Access Compliance Report

Public Rights-of-Way (Curb Ramps)

Intersection ID: 26820	Main Street: MANOR_HOUSE_DR	Cross Street: WHEAT_MEADOW_LN	Location: SW
ADA ID: D6AB89BA054A	Ramp Type: BlendTrans1	Initial Pass/Fail: Pass	Overall Compliance: No
		Severity Score: 5

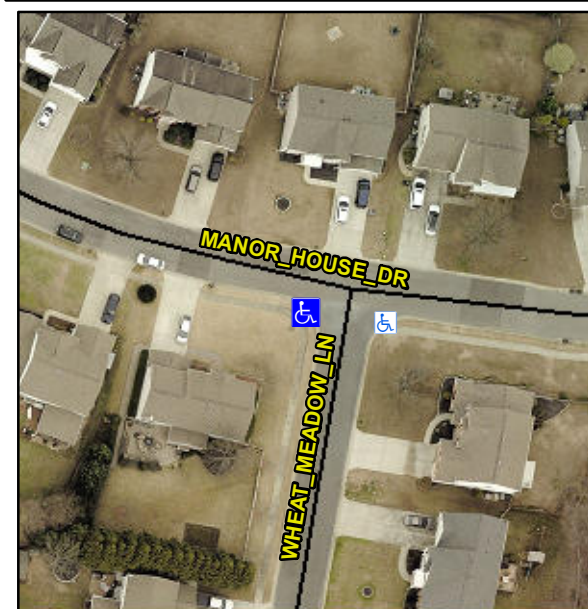
Not Found, R304.2.2-Perp, R304.3.2-Para, R305.2, R304.5.4

N/A	Ramp inside XWalk1?	N/A	N/A	Ramp inside XWalk2?	N/A
	Road Slope (%)	0.5		Clear Space?	Yes
	Road X Slope (%)	1.8	N/A	Clear Space to XWalk (in)	N/A
Yes	Any Obstructions?	No	Yes	Storm Grate/Utility Hazard?	No
	Obstruction Type			Storm Grate/Utility Type	
			N/A		N/A
			Yes	Surface Condition? (G/P)	Good
			No	Curb Slope (%)	12.0

Remove & Replace Curb Ramp With Two New Directional Ramps or Equivalent. Remove & Replace Gutter.
